**TXDOT AVIATION STATEWIDE AIRFIELD ELECTRICAL CONSTRUCTION PROJECT
GROUP ALPHA**

TXDOT CSJ NO.: 4222AVSAEA RE-BID

RE-BID ADDENDUM NO. 1

September 17, 2025

G0.4

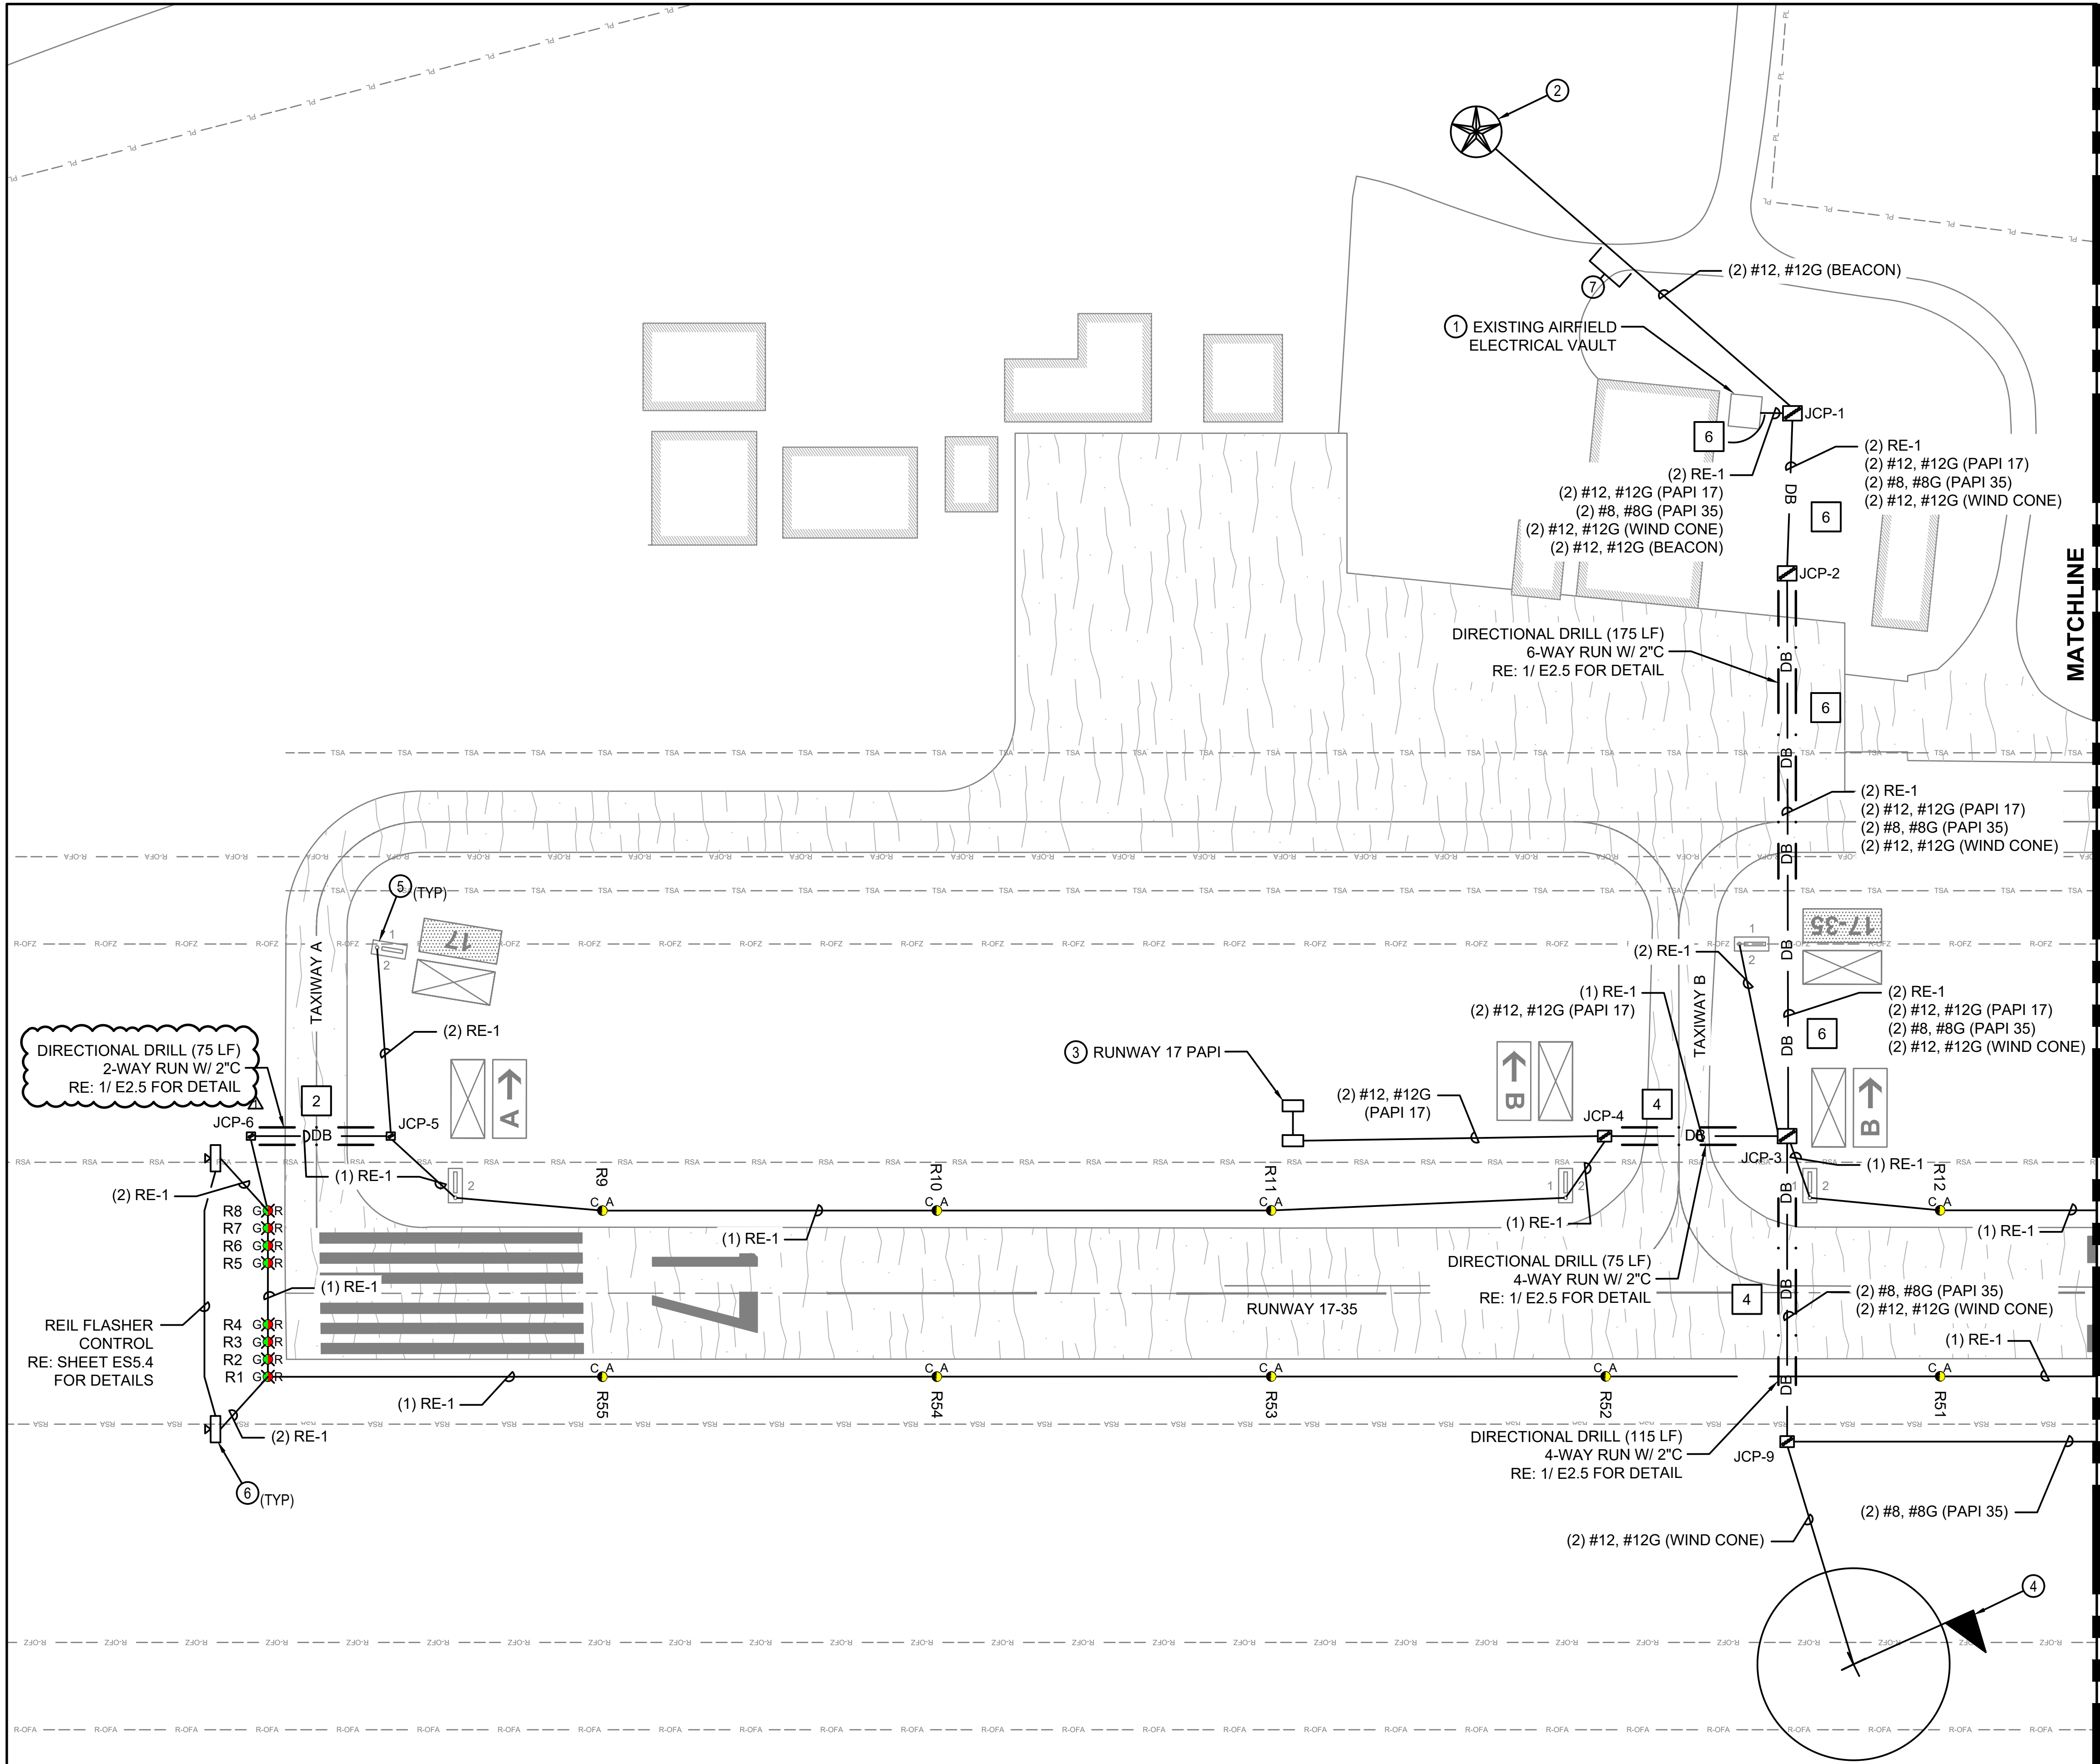
- a) **Two new line items have been added to the Summary of Quantities on sheets**

- i. **Subsequent quantity items to Quantity Item No. 54 have been reordered in numerical order to accommodate new Nos. 55 and 56.**
- ii. **Added Quantity Item No. 55 - Item L-105-5.24 – Remove Concrete Encased Duct in Earth (Including Cable)**

- iii. **Added Quantity Item No. 56 - Item L-105-5.25 – Remove 600V Circuit in Duct**
- iv. **Added Quantity item No. 84 L-110-5.16 - Procure and Install 4-Way, 2" Sch. 40 PVC Conduit, Concrete Encased VIA Open Cut**

AIRFIELD
LIGHTING
LAYOUT PLAN

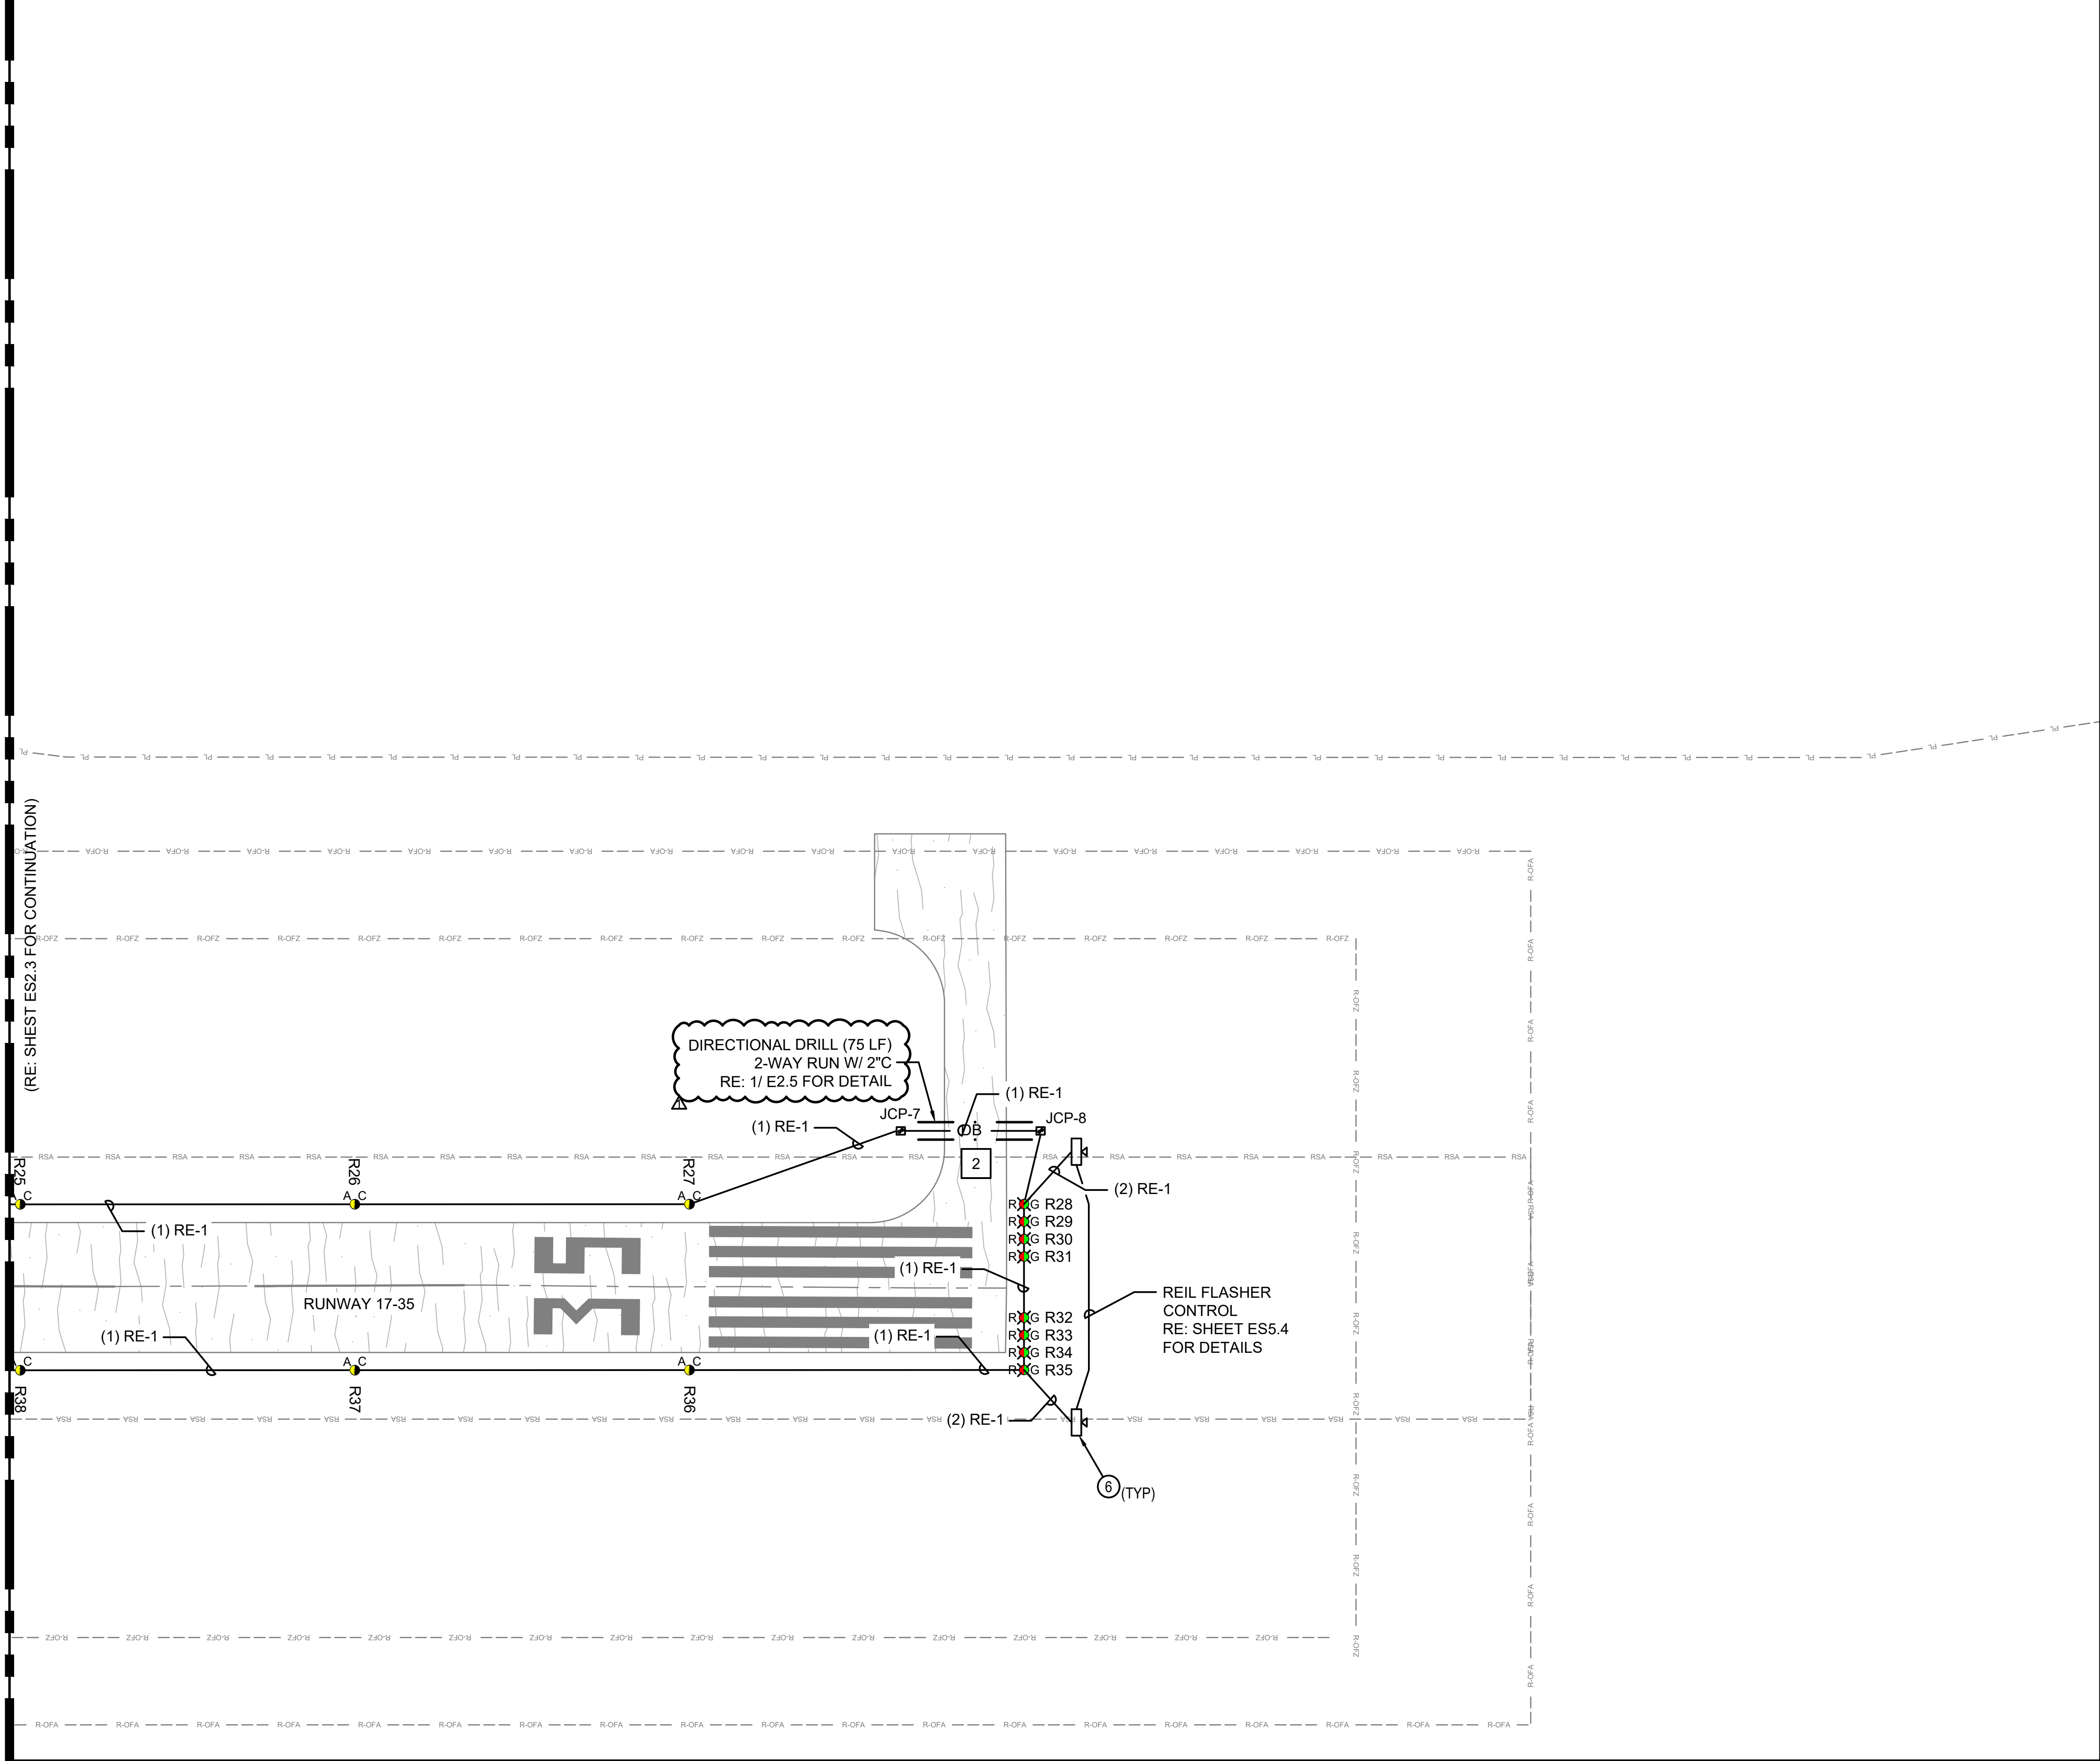
- b) **Directional drill call-outs on sheets ES2.1 and ES2.4 have been updated to reflect the correct quantity of conduits to be installed.**
- c) **Keyed note 7 has been added to sheets ET1.1, ET1.2, ET1.3, ET1.4, and ET1.5 to clarify the airfield guidance sign demolition scope.**

4. For Smithville Airport, page ES2.1 lists a directional drill (75 LF) 4-Way Run with 2" conduit, but also calls out 2 as the number of ducts. Please verify if this is a 2-way or 4-way run with 2" conduit.

RESPONSE: The directional drill callout has been revised. See updated plan sheets included in Addendum 1.
